**WELL CLOSURE METHODS  
AND PROCEDURES  
PHASE II**

**Delivery Order 5031**

**McClellan Air Force Base**

**August 1992**

**FIGURE 2**  
**PRODUCTION WELLS**  
**AT McCLELLAN AIR FORCE BASE**

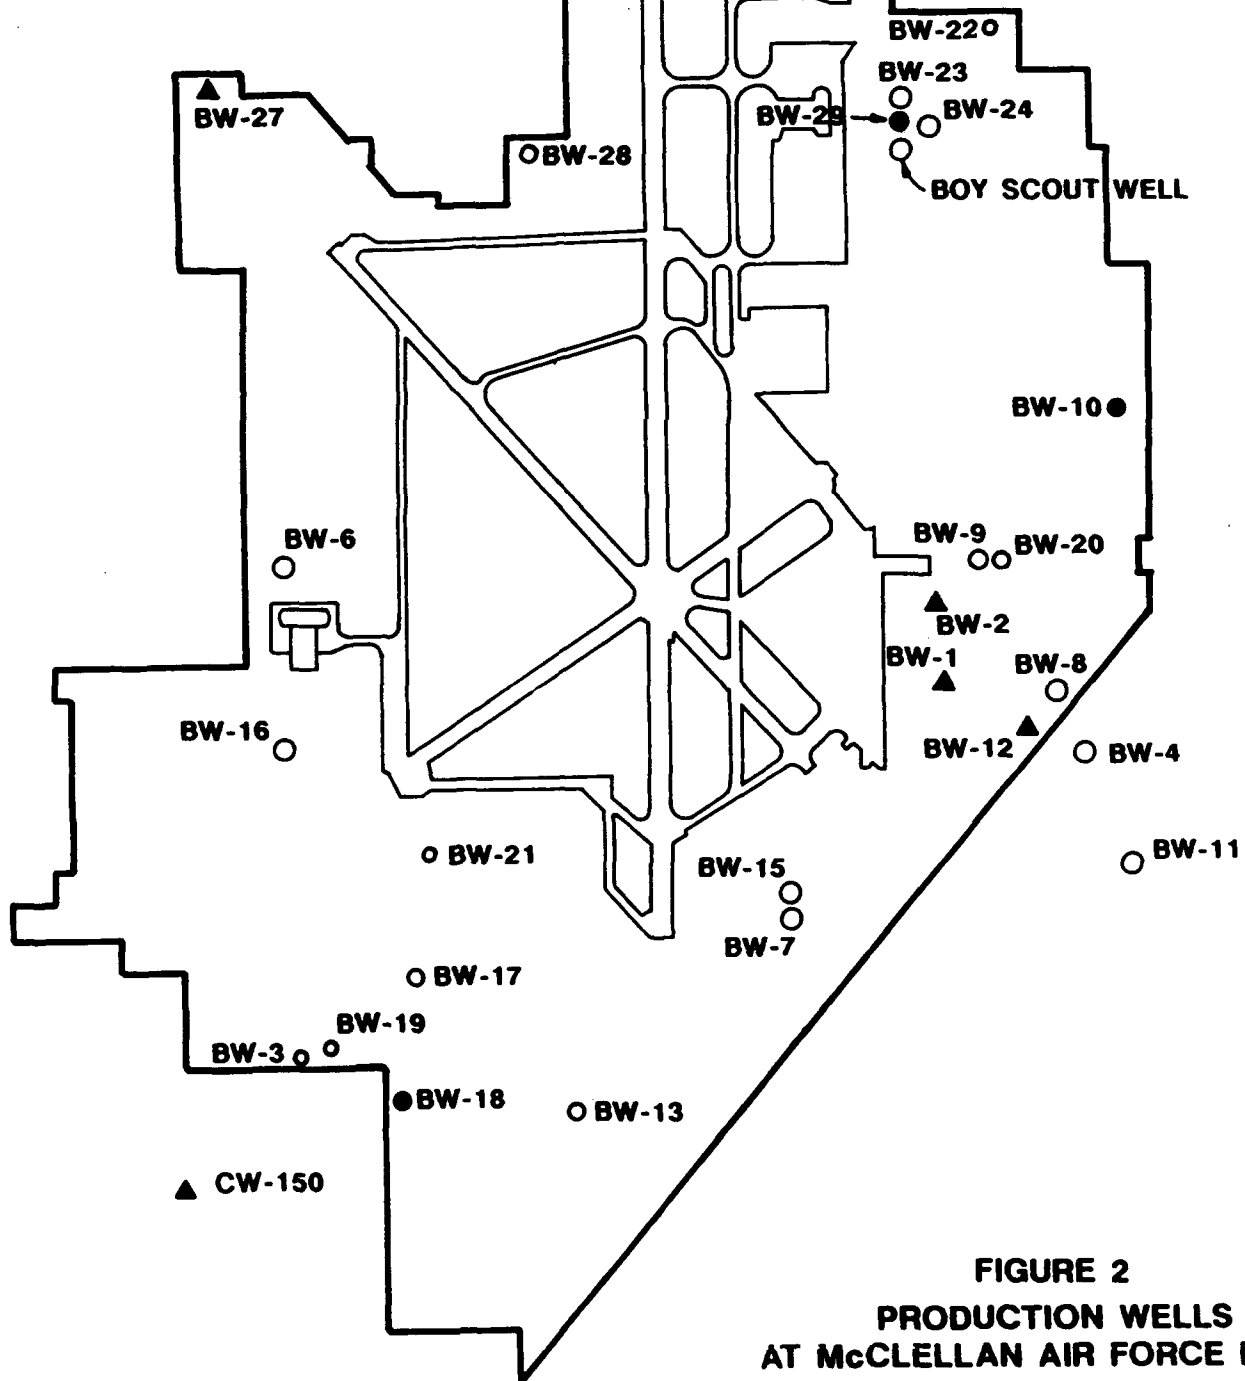
**Comment:** Page 31, paragraph 3, Base Well 6 is not identified on Figure 2.

**Response:** The presumed location of BW-6 will be plotted on Figure 2.
